1	PBY-5	28F6837	1
	MODEL	NEXT ASSY.

NAME ASSEMBLY-FURN.-Y HOT AIR DUCT-SINGLE HEATER

CONSOLIDATED AIRCRAFT CORP. SAN DIEGO, CALIF.

J 28F6815

DETAIL OF -7

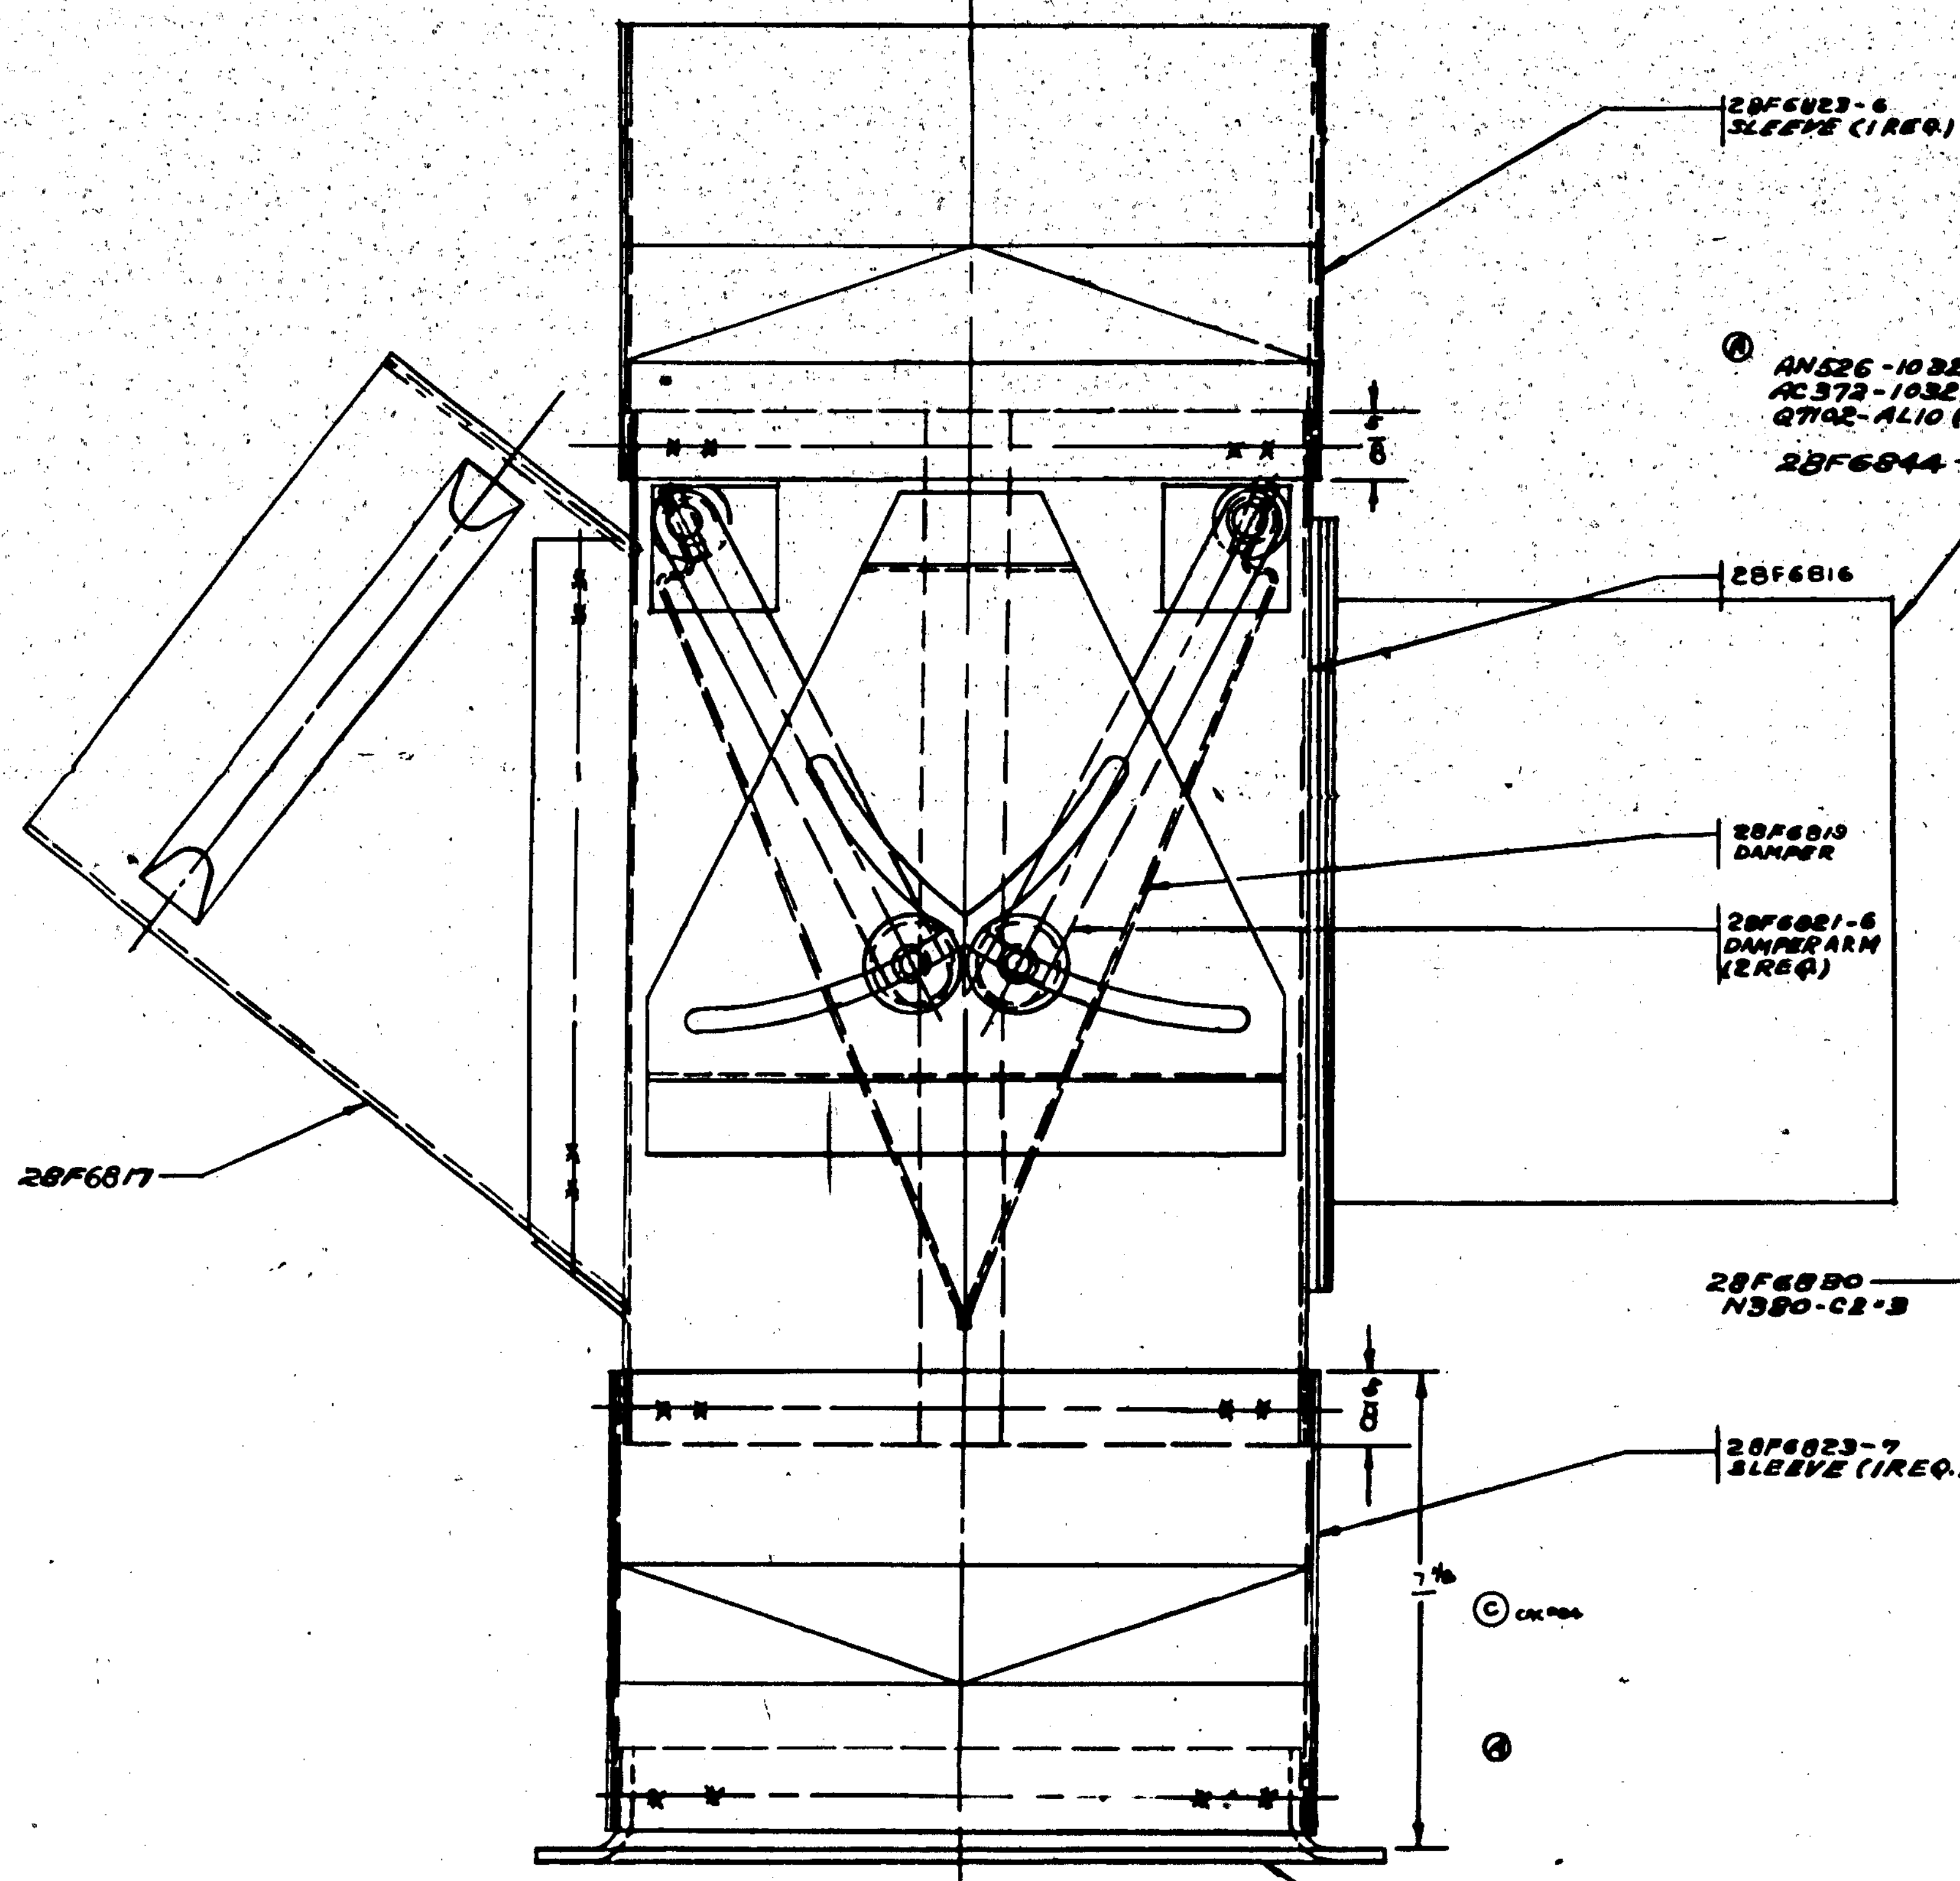
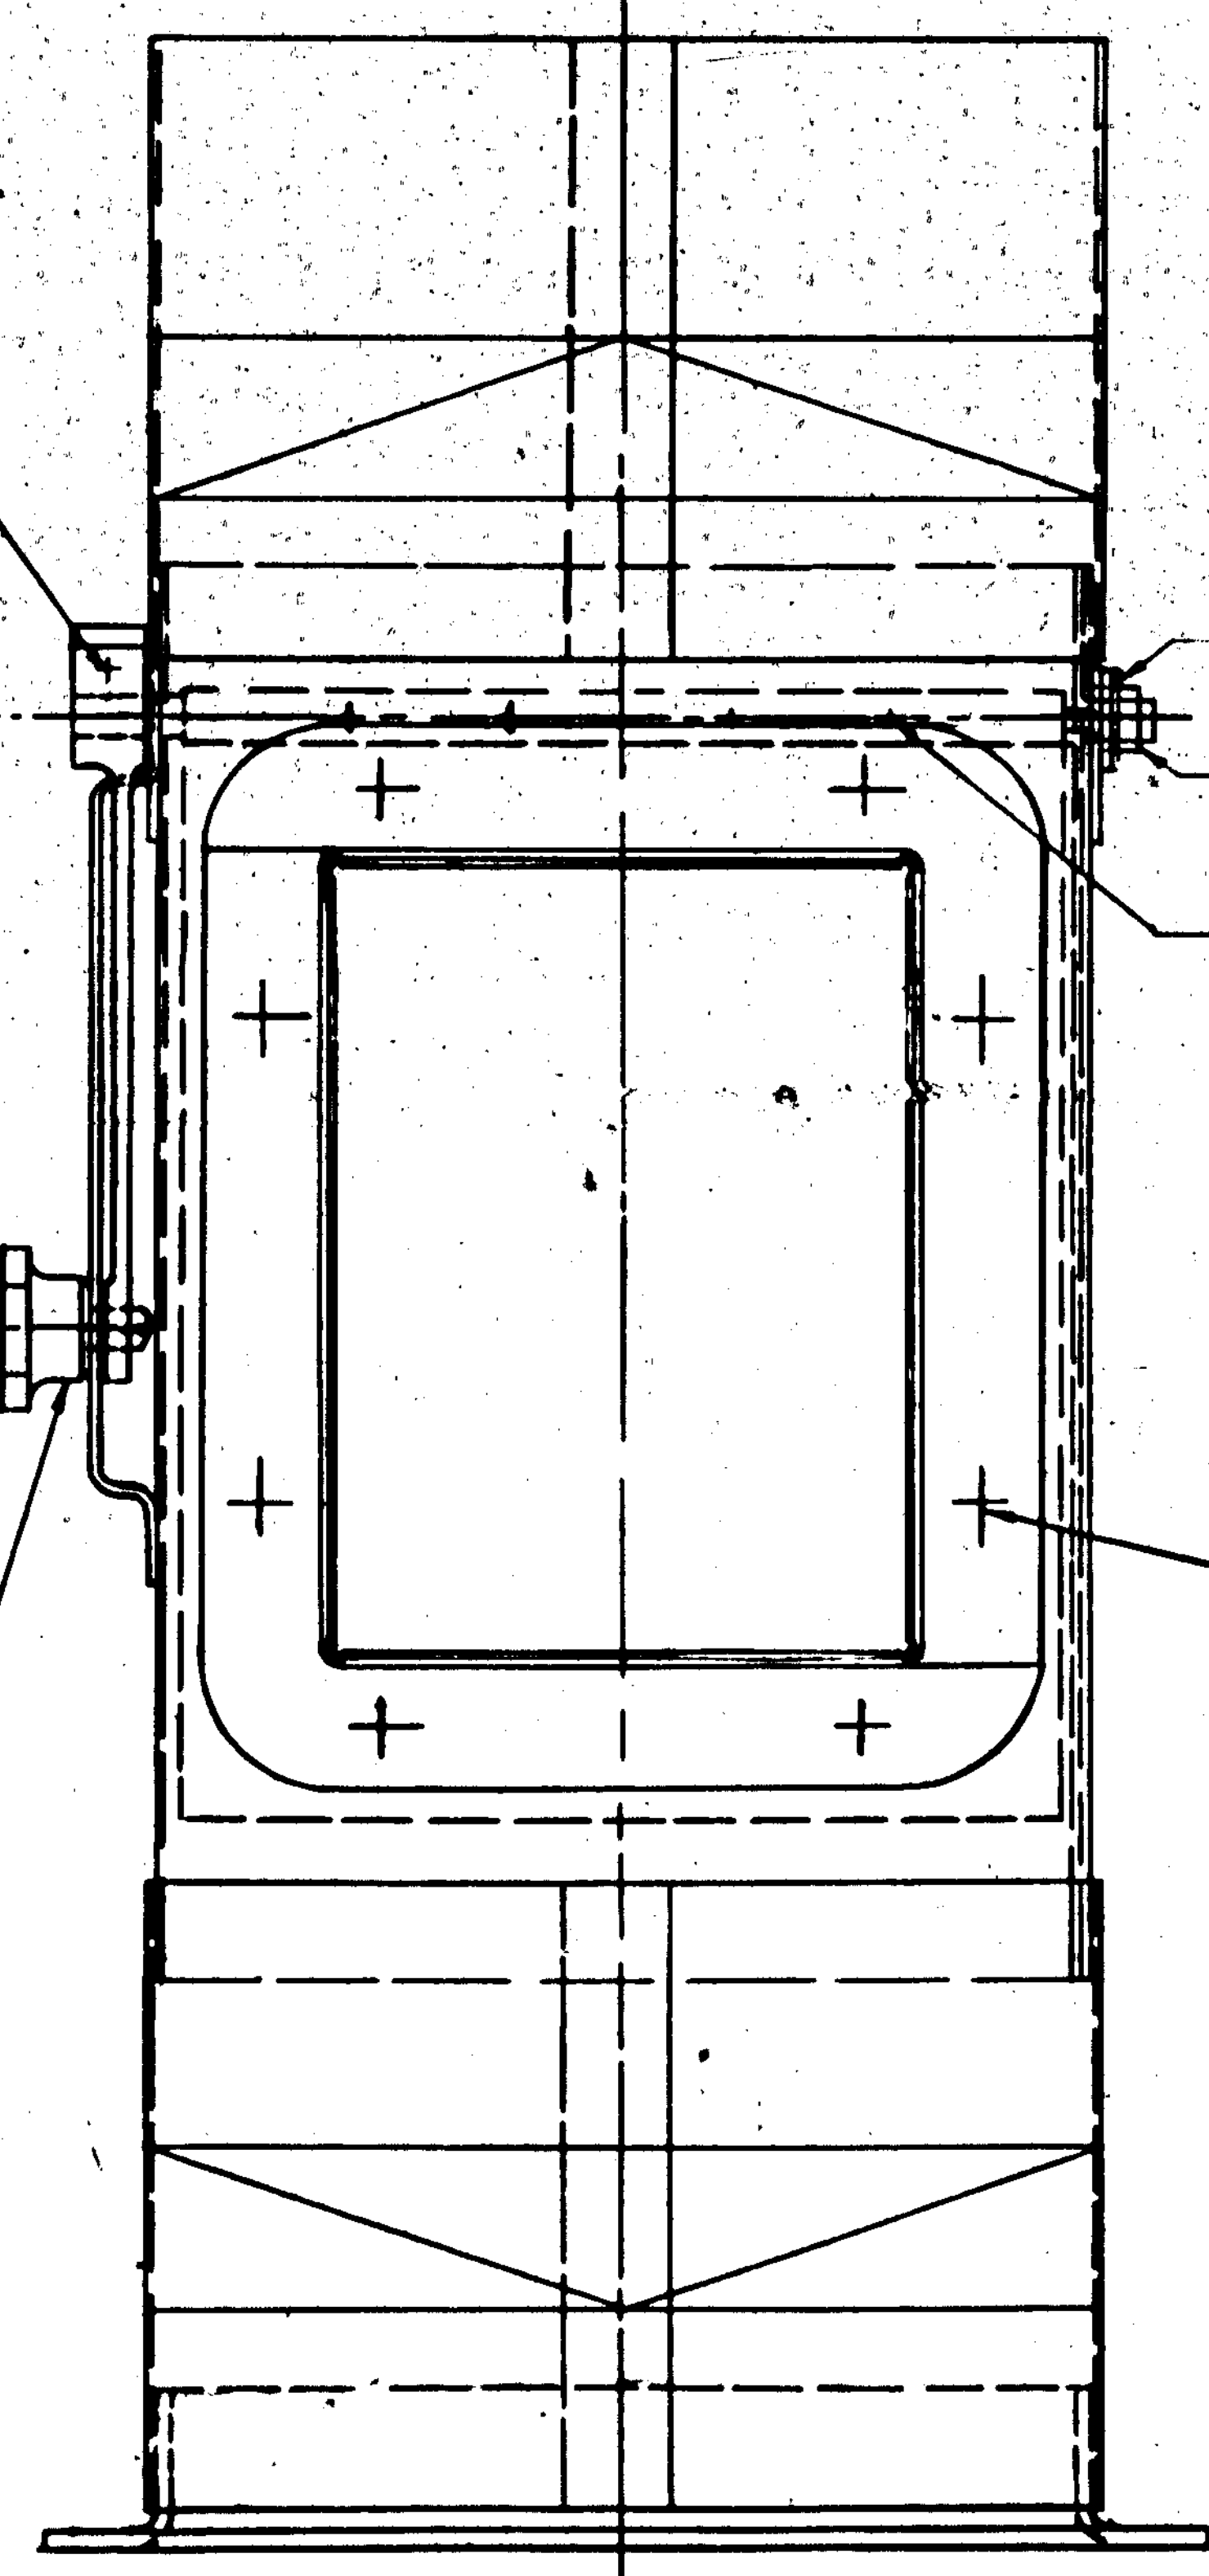
LTR	ALTERATION	DATE	BY
A	CHANGED REQ. OF AN380-C2-3 ... [illegible]		
	RIVETS ADDED AN526-1032-16 (2)		
	AC372-1032 (2) Q7102-AL10 (4)		
	WT. CHANGE NEG.	[illegible]	
B	DIM. 1/8 WAS ... [illegible]		
	... -7 WAS -6. WT. CHG. NEG.	[illegible]	
C	DIM. 7 1/8 WAS ... WT. CHG. NEG.	[illegible]	
D	AN3-04A BOLT ... WAS AN526-...		
	... SCREW. WT. CHG. NEG.	[illegible]
